## Montana Department of Fish, Wildlife & Parks

February 13, 1989

We have found several technical errors in the final protected areas stream reach list. Most of these errors relate to wrong RRN's for protected streams. The discovery of these errors resulted from a further review of our list using the 1:100,000 RRN quad book.

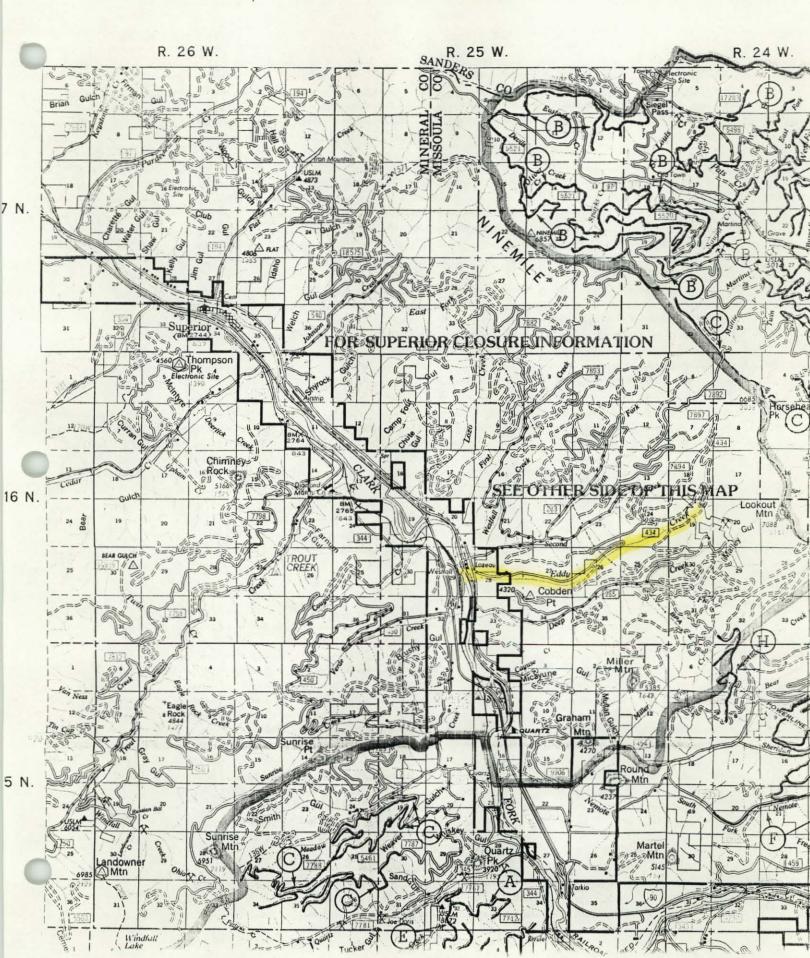
- 1. First, the RRN for Eddy Creek (1701021304900.00) along the lower Clark Fork refers to the wrong Eddy Creek. The Eddy Creek which we intended to protect is located along the north side of the Clark Fork River just upstream of Superior between Second Creek and Deep Creek (see enclosed maps). You'll notice there is no RRN for this Eddy. The Eddy Creek currently on the protected list refers to one across from the Thompson River. The correct Eddy Creek was described on Montana's protected areas maps and lists sent to the Council and public last year.

- 3. The RRN for Rock Creek on the lower Clark Fork (below Missoula) is the wrong one. Instead of RRN =1701021316300.00 (the same one into which the Rock Creek, E Fork flows), the correct Rock Creek RRN should be 1701020414000.00. This Rock Creek is located across from D'Keefe Creek near Missoula (see enclosed maps). Although the number was not correct on the list, the correct Rock Creek location was described on all of Montana's protected areas lists and maps sent to the public and Council last year.
